## MEMORANDUM

**SUBJECT:** Committee of Adjustment Variance Application (MNV)  
Site Plan Control Application (SPC)  
83 John Street, Thornhill  
Proposed two-storey dwelling with integrated garage

**FILE:** A/046/22 & 22 113689 SPC

Proposed site plan (above) and site statistics (below)

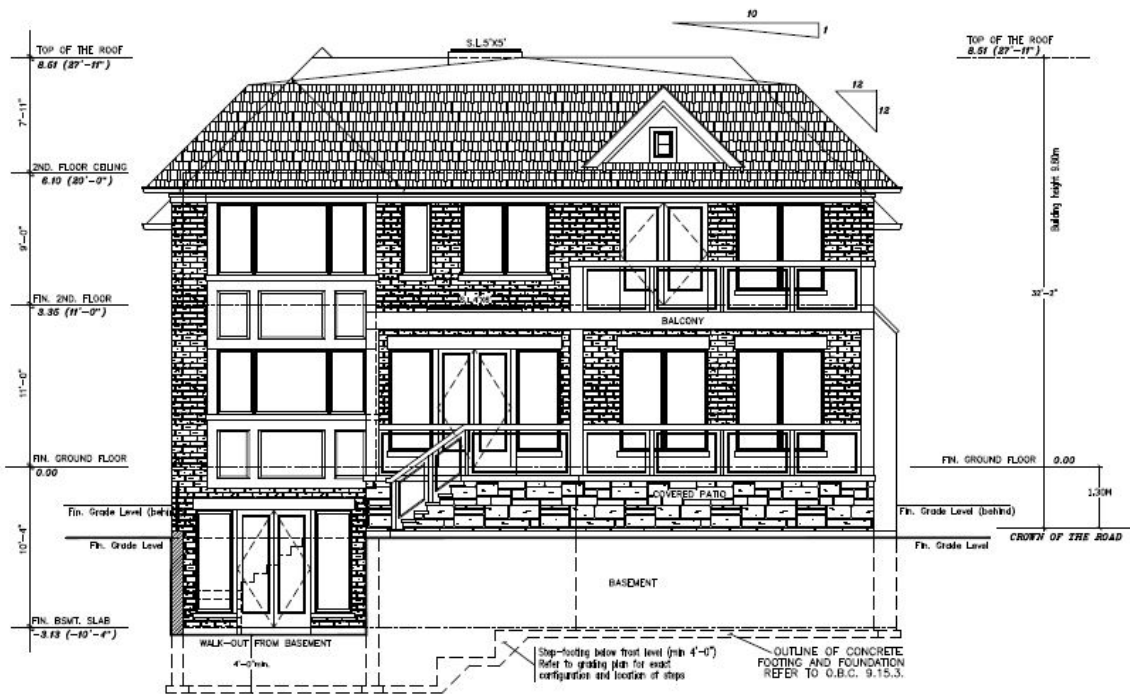
- Heritage Section staff have no objection to the requested variances from a heritage perspective in support of the proposed building design.
- While relief from the zoning by-law is being sought for additional building depth, it is not anticipated to have an adverse impact given the considerable depth of the lot at approximately 55 metres.

- While relief from the zoning by-law is also being sought for floor area ratio, no relief is being sought for lot coverage or building height, both of which are more useful indicators for visual impact on adjacent properties.

- Staff are broadly supportive of the proposed dwelling including its scale, massing, articulation, fenestration and materiality.
- The integrated two-car garage, while located along the primary (north) elevation of the addition, is divided into two bays and is setback relative to the front porch and adjacent bay window. Both reduce the prominence of the garage relative to the remainder of the primary elevation. While the THCD plan provides guidance to locate garages to the rear of the property, the lot is not as deep as the adjacent property at 85 John Street where a rear garage was accommodated without sacrificing rear yard amenity space. Staff will work with the designer through the SPC approvals process to further mitigate the impact of the garage through careful material and colour selection.
